Development Permit with Variance No. DP-449

REQUEST FOR DECISION

Title: Development Permit Application No. 449

Legal: Lot 5, Section 12, Township 20, Range 10, W6M, KDYD, Plan 782 Except Plan B5363
Civic: 1150 12 Avenue SE
Owner: Sunnyhill Town Homes Ltd.
Agent: Flat Architecture Inc. (R. Warraich)

BUILDING 1
SCHEME-01

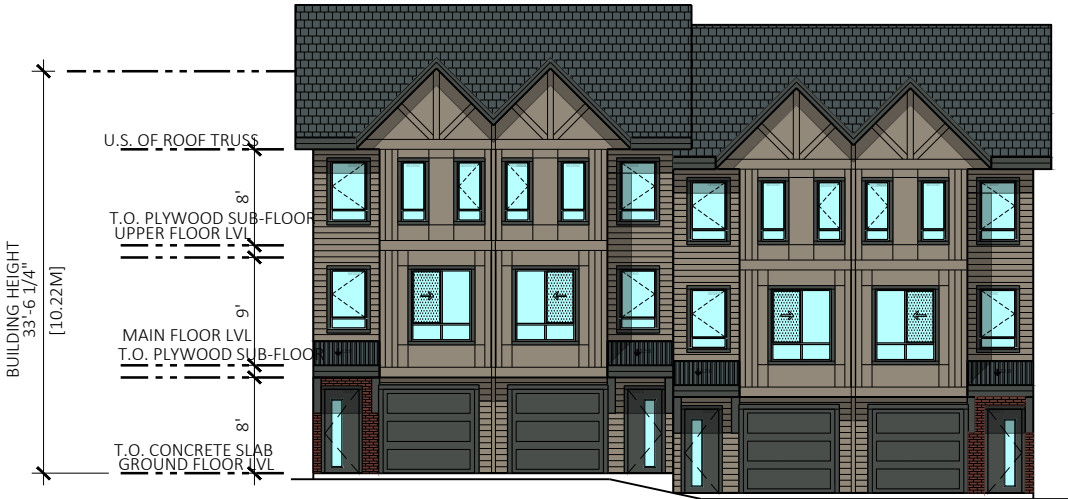
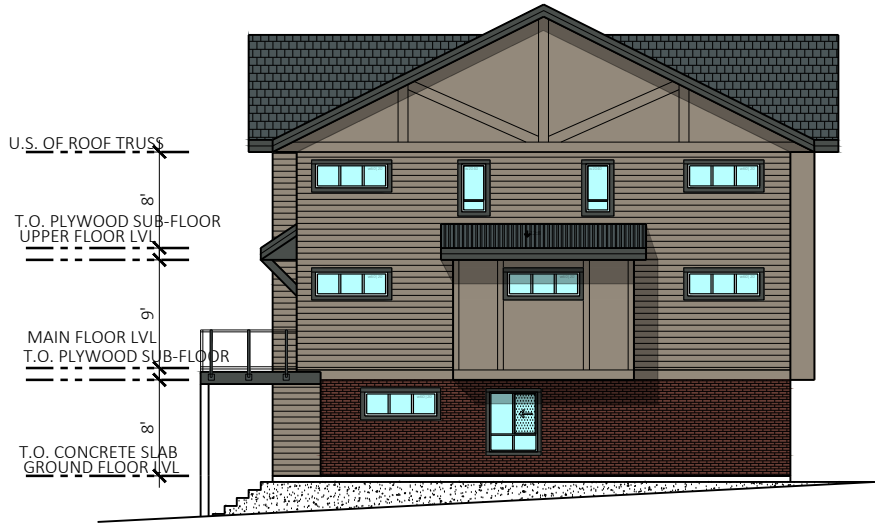
- .1 Reduce the front parcel line setback from 5 m to 3.5 m
for a deck on Building 1
- .4 Reduce the exterior side parcel line setback from 5 m
to 3.5 m for decks on Buildings 4 and 9
- .5 Reduce the minimum clear driveway length for
accessing any garage or carport from 5 m to 0.6 m

The proposal includes a variance request to reduce the front and exterior side parcel line setbacks from 5 m to 3.5 m to allow decks that project into the front and exterior setbacks. Zoning Bylaw No. 2303 also requires a minimum clear driveway length of 5 m for accessing any garage or carport. The proposal includes a variance request to reduce the setback from 5.0m to 0.6 m driveways. Not all driveways are 0.6m in length, the driveway lengths vary from 1.3 to 0.6m.

The proposed projection of decks into the setback areas is relatively minor, as highlighted in Appendix 14. The decks are unenclosed and do not significantly add to the building massing. Some of the decks in the setback areas are along exterior parcel lines and therefore do not impact adjacent properties.

A letter of rationale for the requested variances is attached as Appendix 13. A site plan showing the requested variances is attached as Appendix 14. In considering the factors noted above, staff are not concerned with variance requests.

BUILDING 9
SCHEME-01

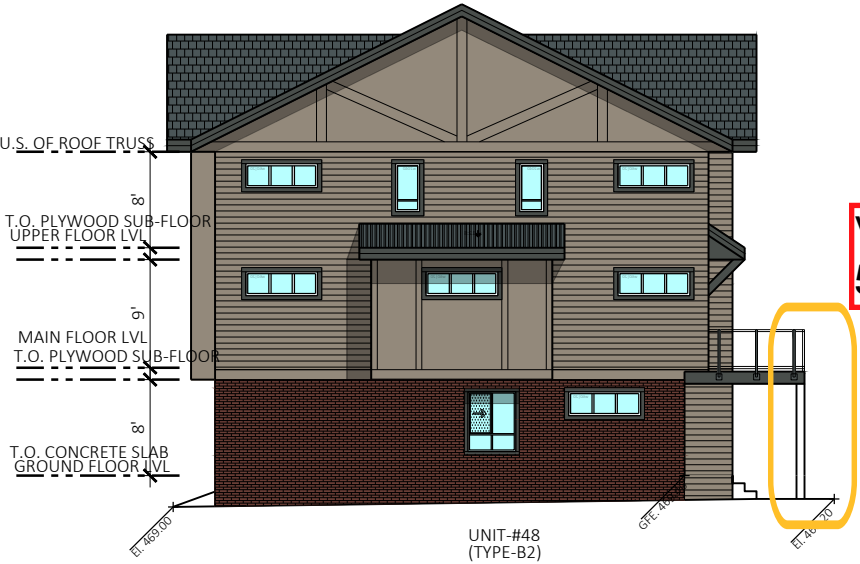
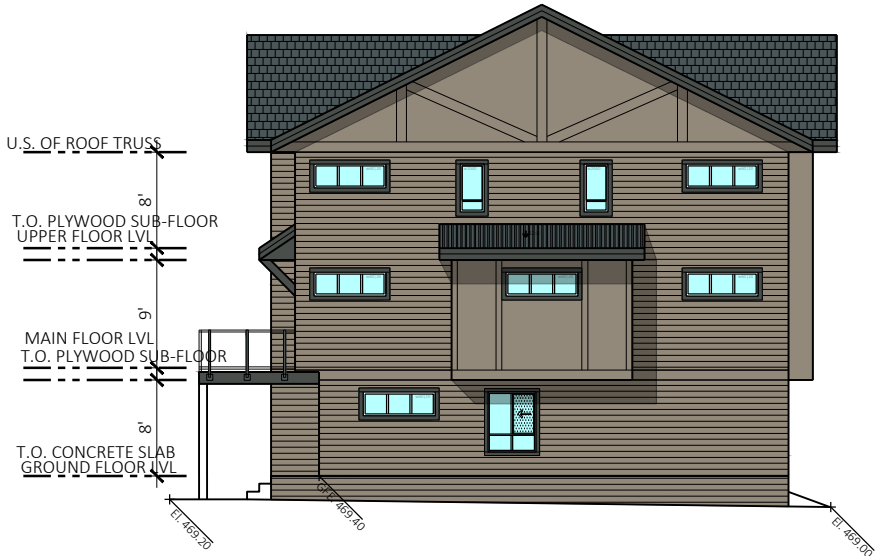
VARIANCE
5.0m to 3.5m (Deck)
